Project: **MOUNTAIN ISLAND MARKETPLACE**
N.C. HUY 16 and MT. HOLLY - HUNTERSVILLE RD.
 Sheet Title: **REVISED SITE PLAN "FOR PUBLIC HEARING"**
 PETITION NO. 93-33 (C)

CHARLOTTE - MECKLENBURG PLANNING COMMISSION
INTER-OFFICE COMMUNICATION

DATE: May 24, 1994
 TO: Robert Brandon, Zoning Administrator
 FROM: Martin R. Cramton, Jr., Planning Director
 SUBJECT: Administrative Approval for petition 93-33(c) by Crescent Resources Tax Parcel # 033-012-26,27,37

Project: MOUNTAIN ISLAND MARKETPLACE
N.C. HWY 16 and MT. HOLLY-HUNTERSVILLE RD.
Sheet Title: REVISED SITE PLAN "FOR PUBLIC HEARING"
PETITION NO. 93-33 (C)

SITE PLAN
SCALE: 1"=60'

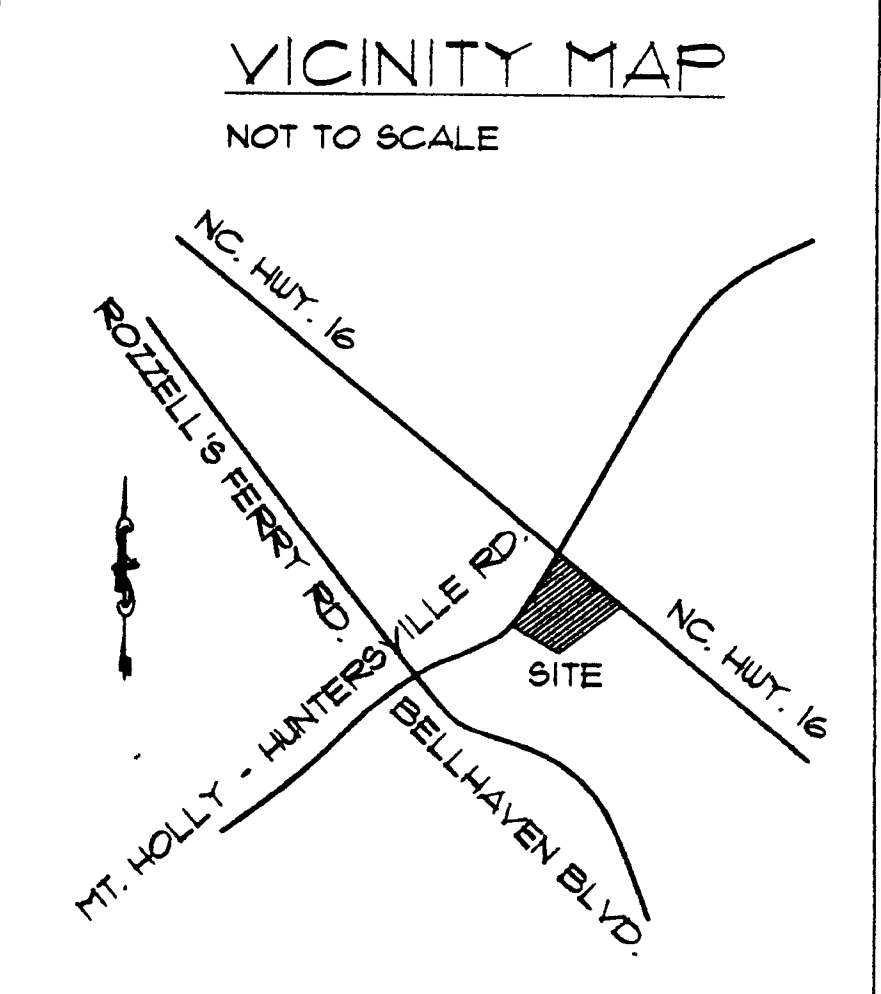
Attached are a set of revised plans for the above mentioned rezoning petition. The plans have been revised to allow the developer to build up to 500 square feet more of retail space within phase one bringing the total allowed square footage within phase one to 73,500 square feet. In addition the construction of the permanent storm water detention facility has been delayed until the remainder of parcel one is built out in the interim two temporary storm water detention ponds will be constructed on the site. These two ponds will be removed when parcel one is completed. Finally the developer has requested as a point of clarification that he be allowed to grade within the 75 foot buffer located along the southern property line. Since this buffer is a buffer as per section 12.301 of the zoning regulations and the conditional plan did not specify that it would be undisturbed we have told the developer that grading within this buffer is allowed so long as any slopes that remain within the buffer be no greater than 3 to 1. Since these changes are minor I am administratively approving this revised plan. Please use this revised plan when evaluating requests for building permits and certificates of occupancy.

Wendy's Mt. Kladid Marketplace	
LANDSCAPE PLANNING PLAN	SCALE: 1"=20'-0" DRAWN BY: [Signature]
THE SOUTHERN TREE & LANDSCAPE CONTRACTORS	DATE: 6-20-95 APPROVED BY: [Signature] DRAWING NUMBER: 2118

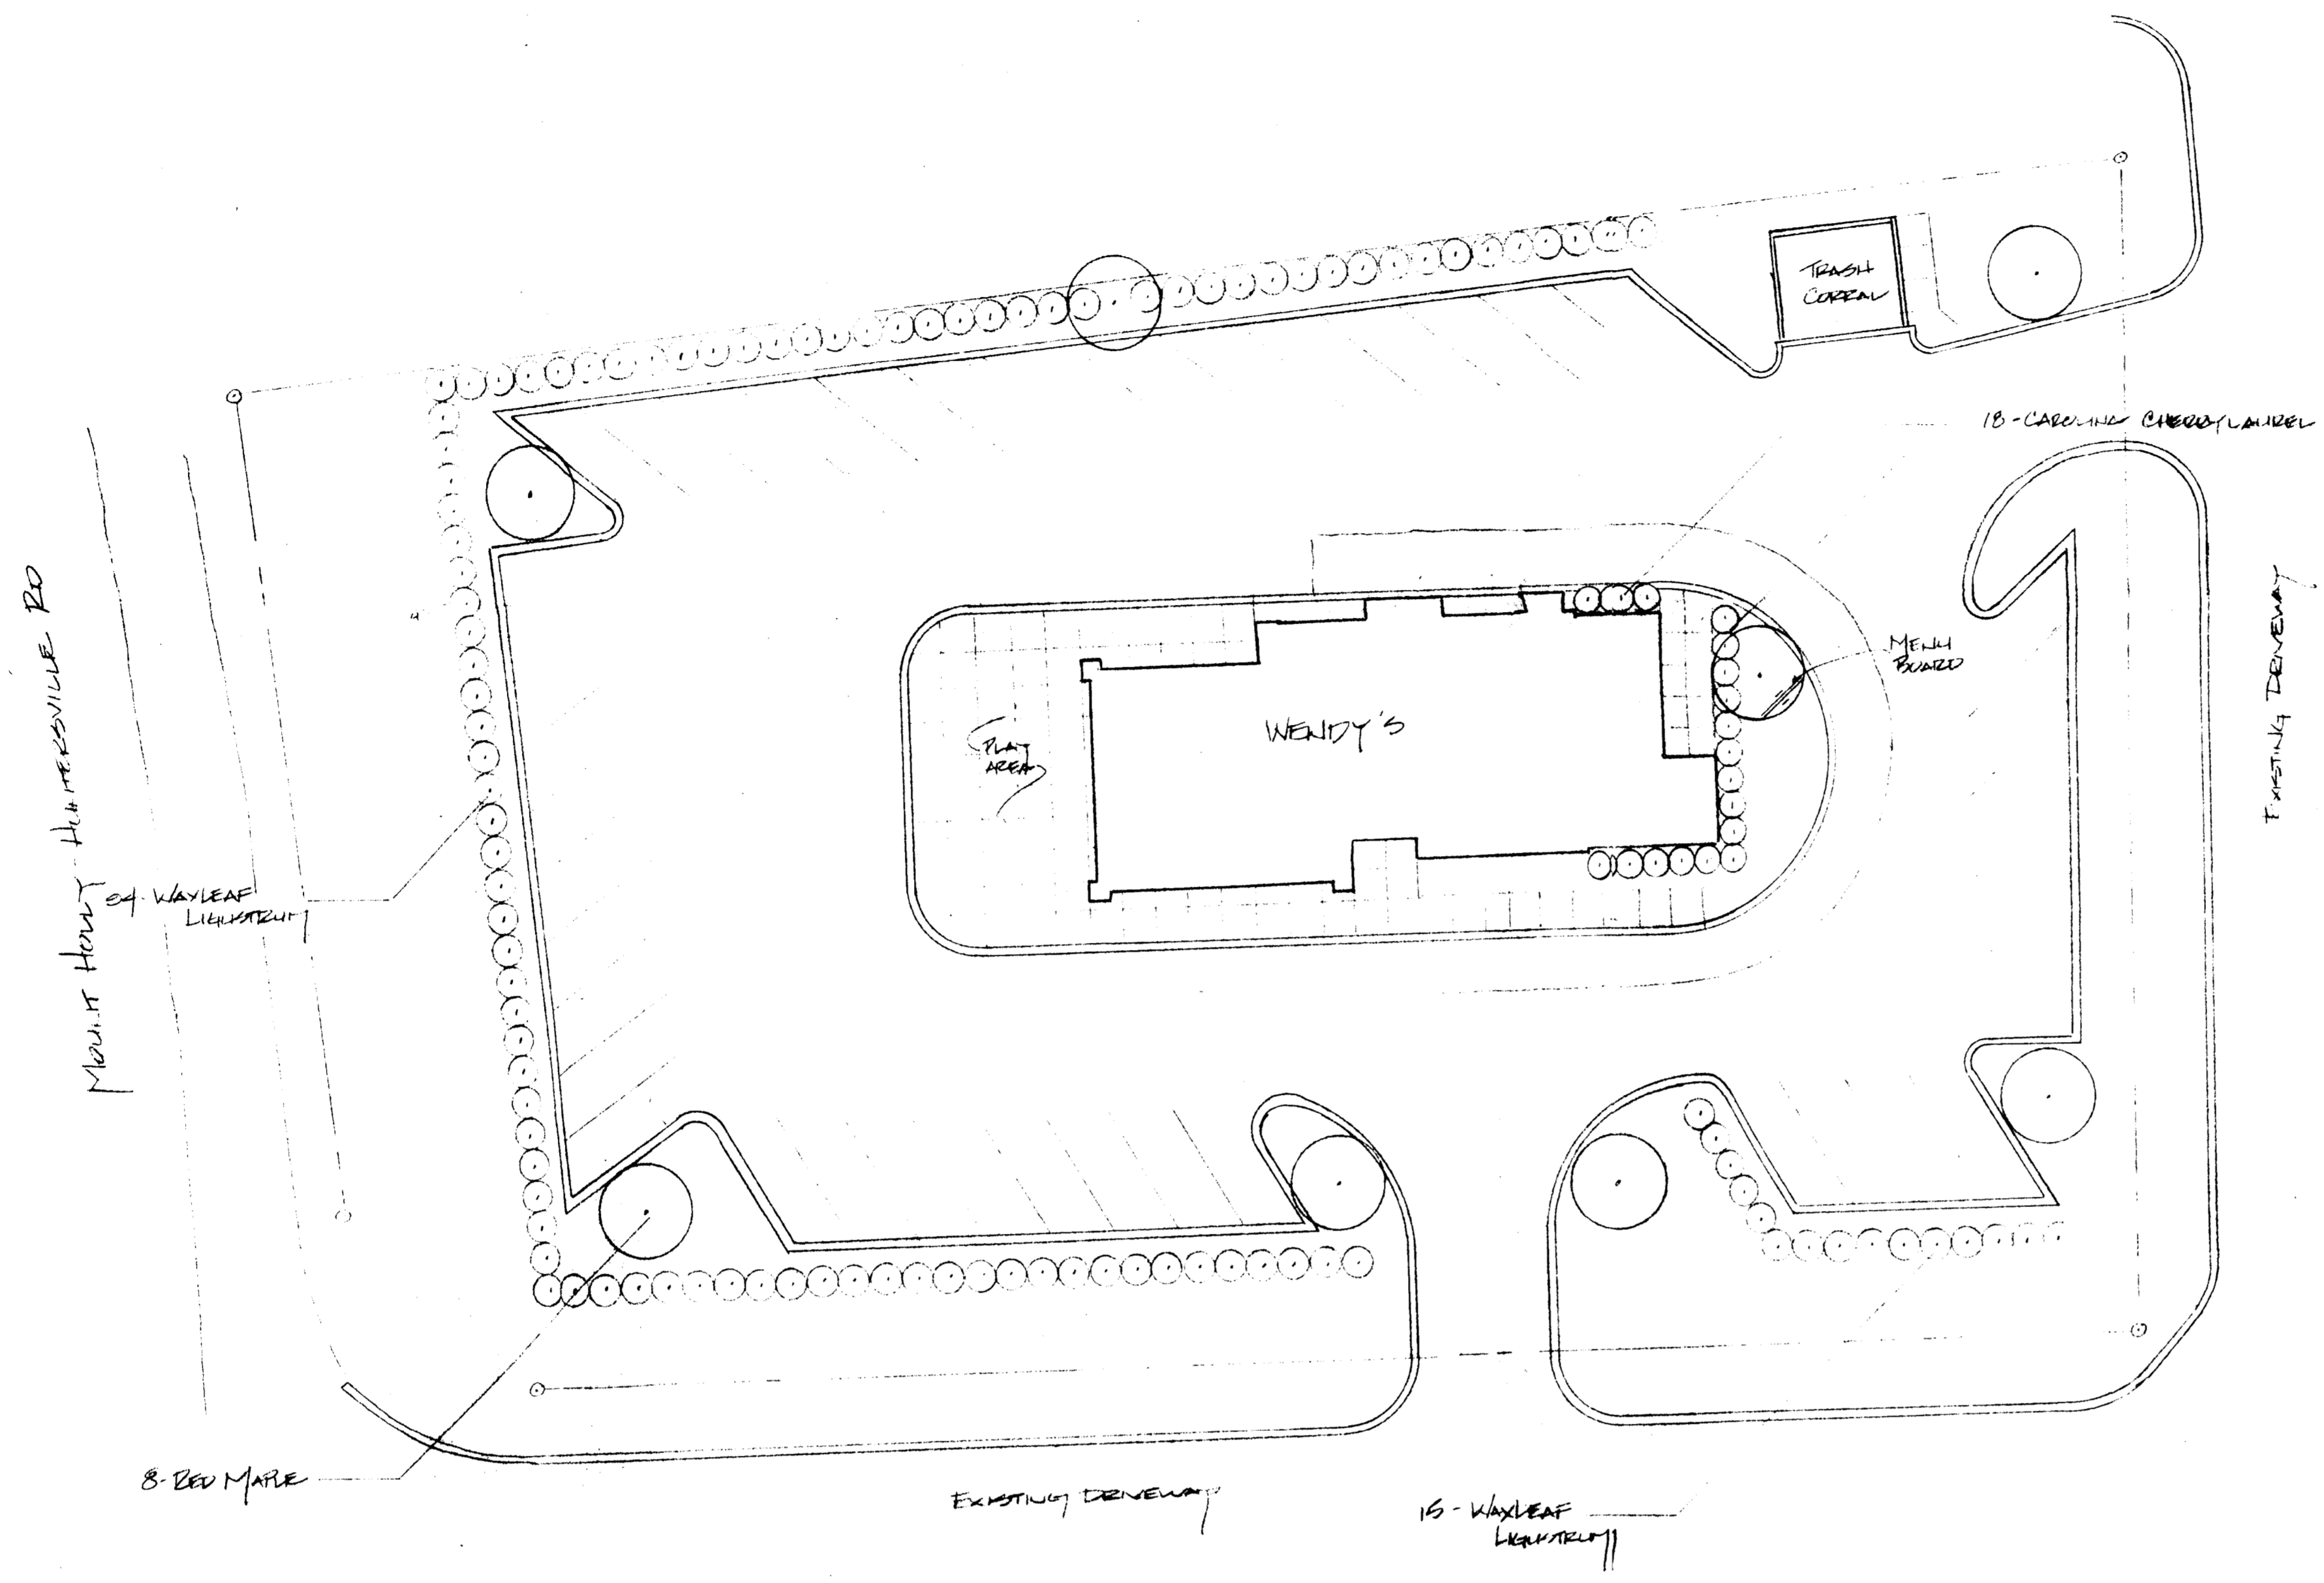
Attached is a specific plan for one of the outparcels at the above mentioned rezoning petition. This outparcel is been developed with a Wendy's. We have reviewed the building elevations for this Wendy's and find them compatible with the shopping center. This compatibility has been achieved by the use of the same brick and split face block and colors as the shopping center. Since the Wendy's has used the same materials and colors as the shopping center we are administratively approving this plan. Please use this plan when evaluating requests for building permits and certificates of occupancy.
